**CITY OF TEMPE
DEVELOPMENT REVIEW COMMISSION**

**Meeting Date: 8/11/2020
Agenda Item: 10**

ACTION: Request a Use Permit to exceed 125% of the minimum parking and a Development Plan Review for a new 718 square-foot restaurant (take-out) building with a drive-through for SALAD & GO, located at 3229 South 48th Street.

DATE: 07/21/20
 PERMITTED BY: PERMIT SUBMITTAL
 REVISION NO.:
 SHEET TITLE: SITE PLAN V12
 SHEET NO.: AS.2

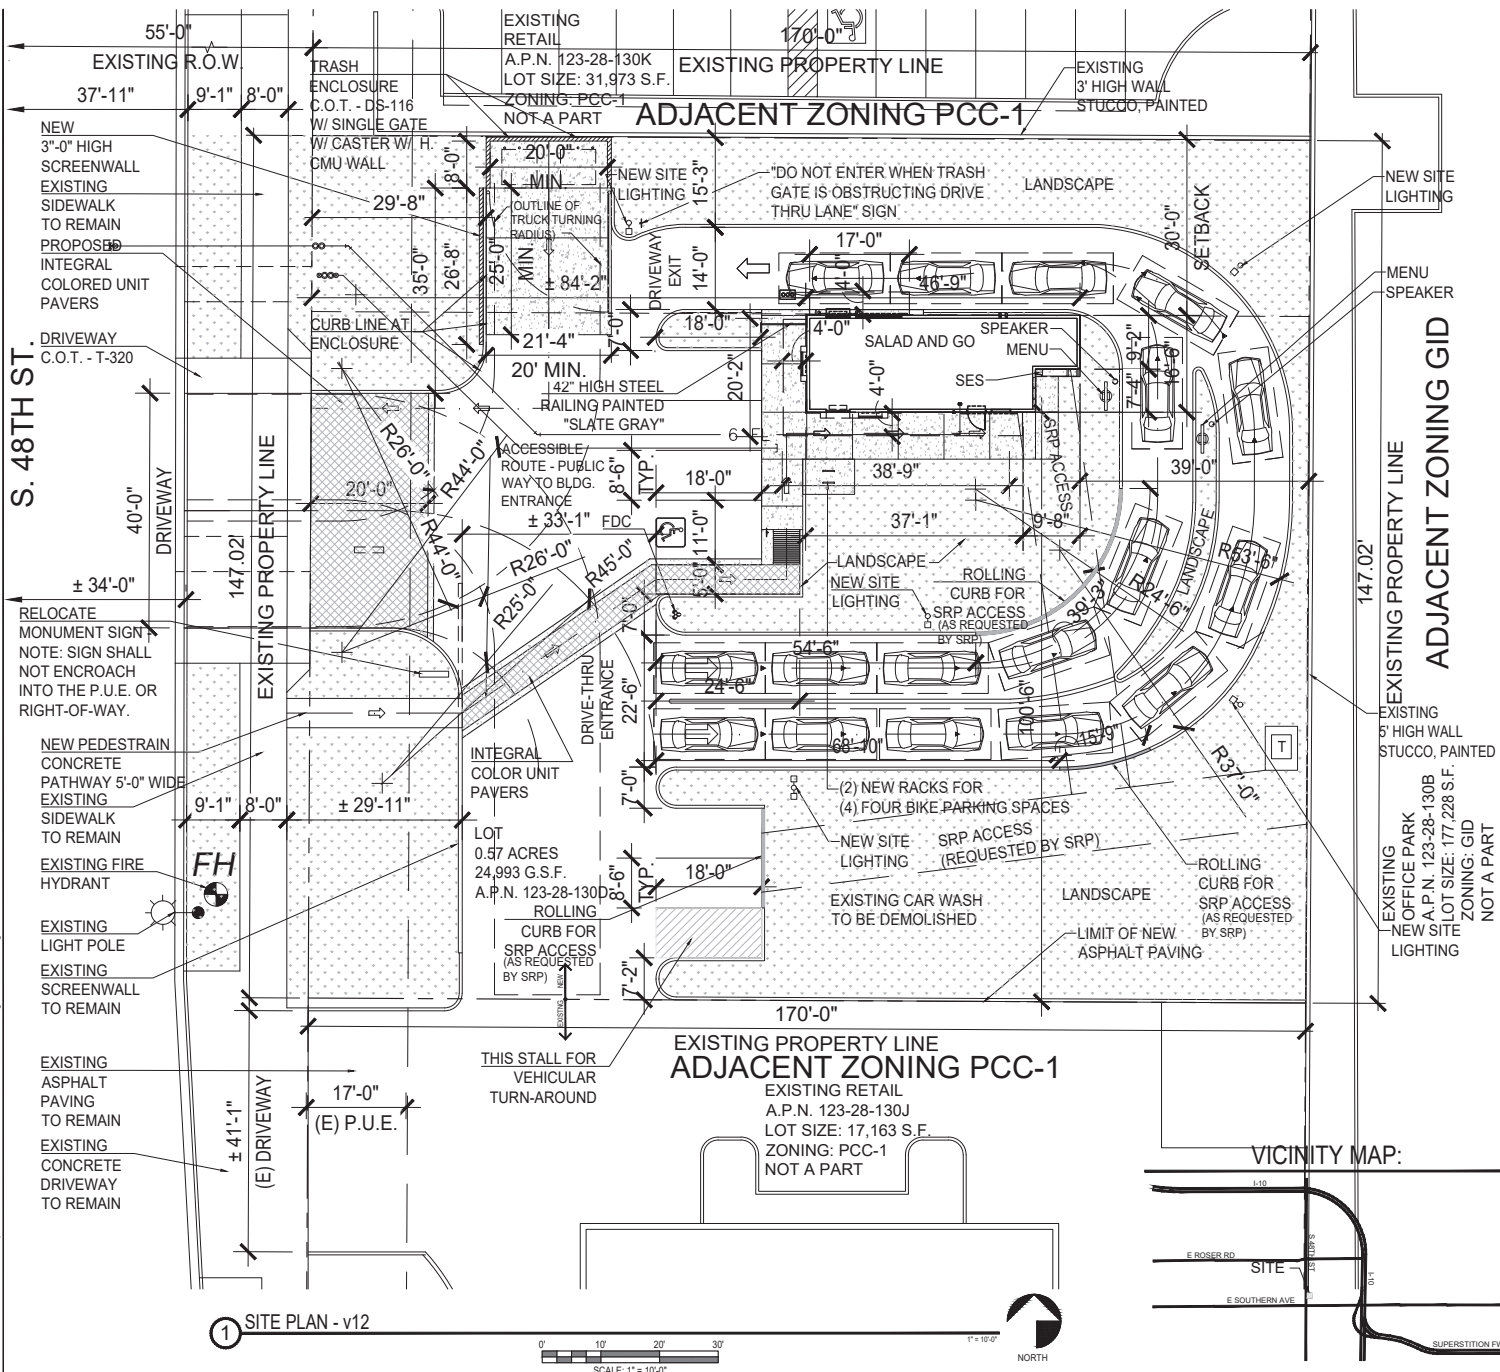
1. Site Plan
 - a. *Planning Staff requested upgraded paving at the driveway consisting of integral colored unit paving; the applicant accommodated the request.*

- b. *Transportation Staff requested a pedestrian connection from the right-of-way to the building; the applicant accommodated the request.*
 - c. *Planning Staff requested additional landscape area to the south quarter of the site in lieu of pavement to mitigate heat gain/retention while providing shade for energy conservation and human comfort; the applicant accommodated the request.*

- d. *Solid Waste Services Staff requested a double refuse enclosure with a single gate to prevent drive through traffic from impeding refuse vehicles during collection times; the applicant accommodated the request.*

- e. *Planning Staff requested a site circulation design that can function independent of the existing cross-access to and from the lot to the south; the applicant accommodated the request by shifting the refuse enclosure further north and the driveway further south for adequate refuse truck maneuvering.*

3. Provide upgraded paving at each driveway consisting of integral colored unit paving. Extend this paving in the driveway from the right-of-way line to 20'-0" on site and from curb to curb at the drive edges. From sidewalk to right-of-way line, extend concrete paving to match sidewalk.

sheet title:
LANDSCAPE PLANTING PLAN

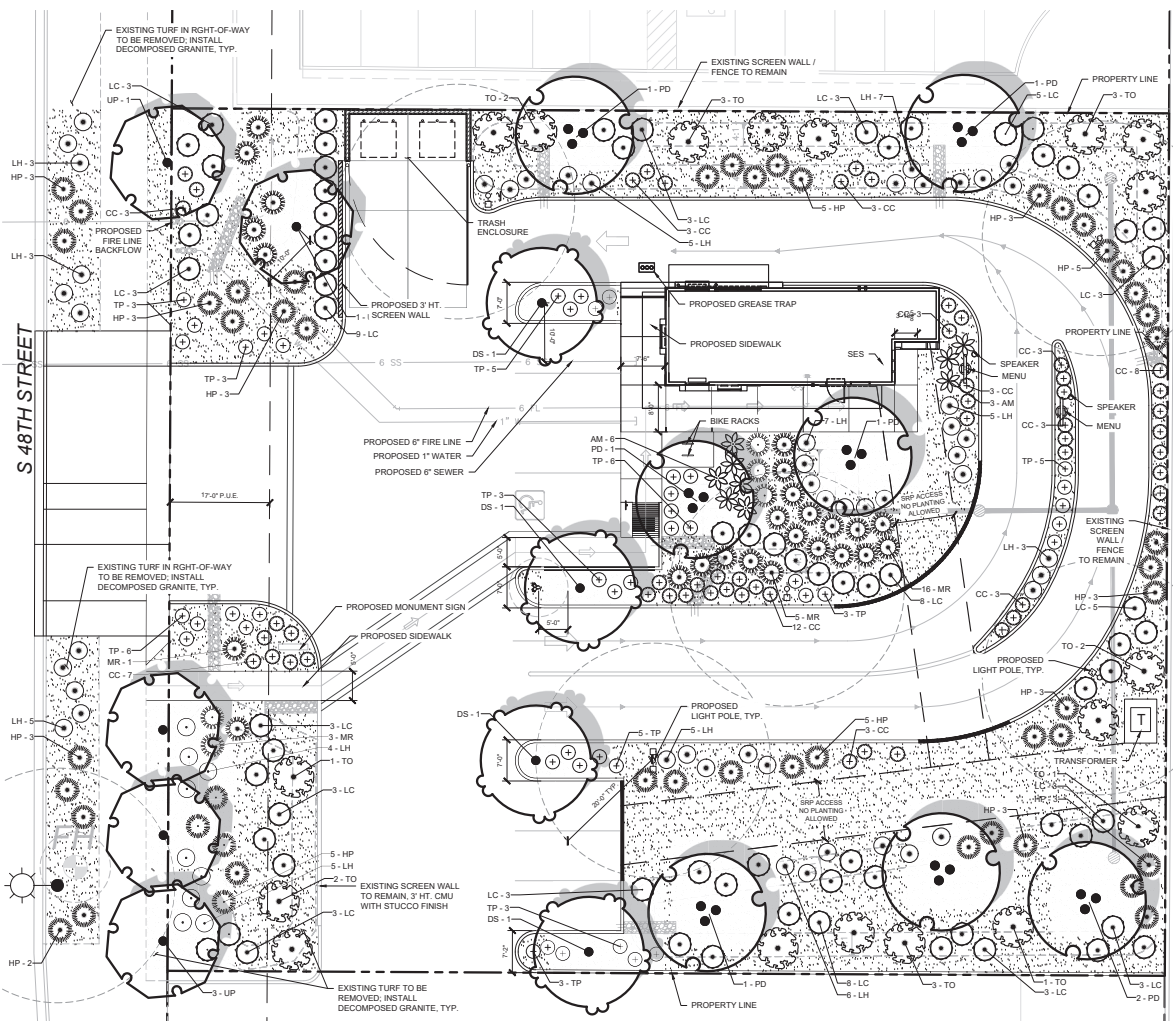
- a. *Planning Staff noted that the existing palm trees may remain but will not contribute to the required number of street trees since they do not provide an adequate shade canopy; the applicant acknowledged the note and provided shade trees along the frontage landscape areas.*

- b. *Planning Staff requested 70% vegetative landscape coverage within the landscape areas near the front and 50% coverage within the areas at the rear; the applicant accommodated the request.*

- c. *Planning Staff requested integral unit pavers to delineate pedestrian path from the asphalt; the applicant accommodated the request.*
- d. *Planning Staff requested multi-trunk trees within the larger landscape areas along the south and southeast corner of the site; the applicant accommodated the request and included vegetative ground cover.*

- e. *Planning Staff requested shifting the street trees closer to the public sidewalk between the 17-foot wide public utility easement and the back of sidewalk; the applicant accommodated the request.*

sheet title:
EXTERIOR ELEVATIONS

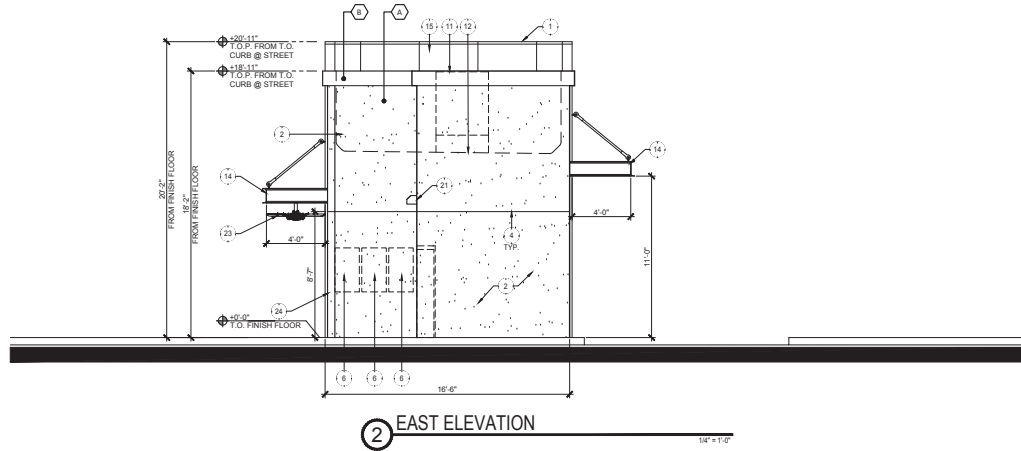
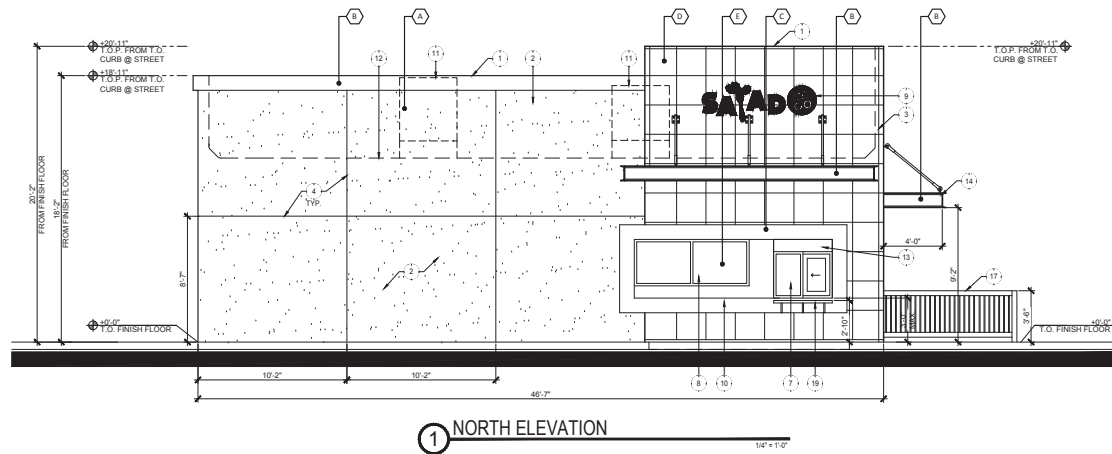
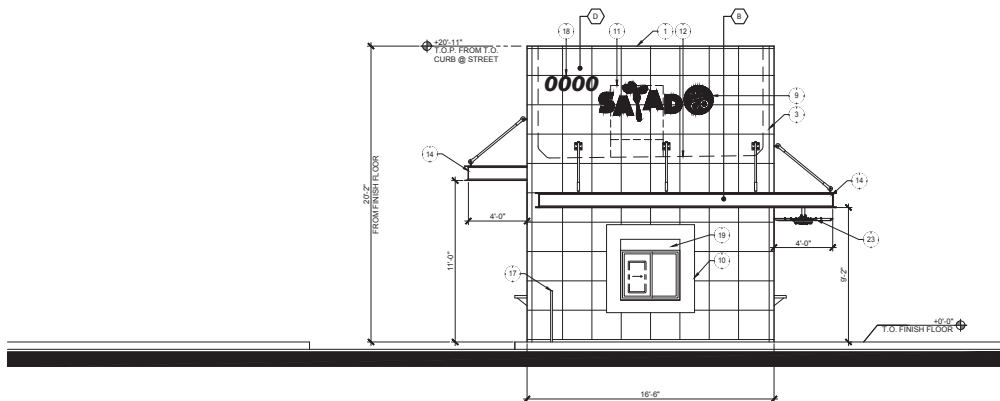
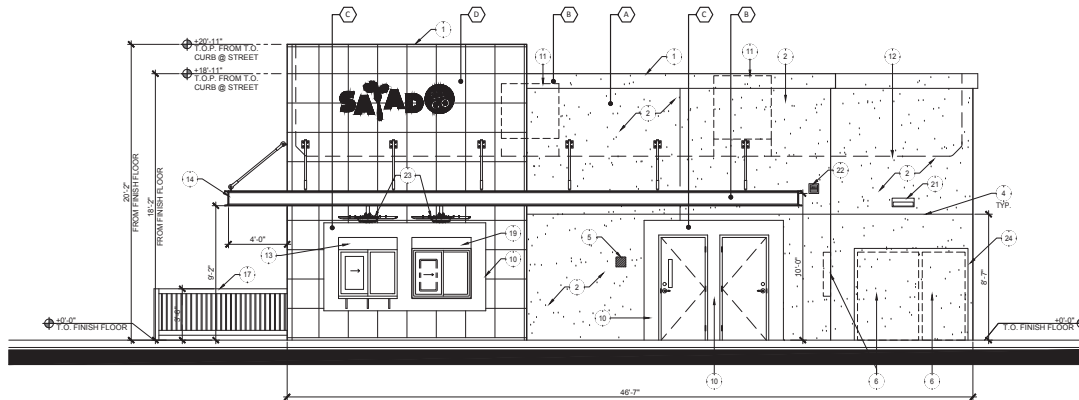
2. Building Elevations
 - a. *Planning Staff requested a carry-out/pick-up window on the west elevation; the applicant accommodated the request.*
 - b. *Planning Staff requested additional stucco reveals throughout the building; the applicant provided additional vertical reveals throughout the building.*

- c. *Planning Staff requested a primary building color with a Light Reflectance Value (LRV) of 75 or less; the applicant accommodated the request by providing a primary color with an LRV of 74.*

- d. *Planning Staff requested an air curtain system that is recessed and architecturally integrated into the building; the applicant accommodated the request.*

- e. *Planning Staff requested a recessed S.E.S; the applicant accommodated the request.*

7. The materials and colors are approved as presented:
Primary Building – Painted Smooth Stucco by DRYVIT – Sherwin Williams – “Incredible White” #SW7028
Secondary Building – Metal Panel Siding – CF Architectural Panel – “Slate Gray”
Building Accent – Sherwin Williams – “Electric Lime” #SW6921
Parapet Accent and Canopies – Painted Metal – Sherwin Williams – “Navel” #SW6887
Windows – Aluminum Storefront by Kawneer – “Clear Anodized”
Glazing - Clear
Provide primary building colors and materials with a light reflectance value of 75 percent or less.
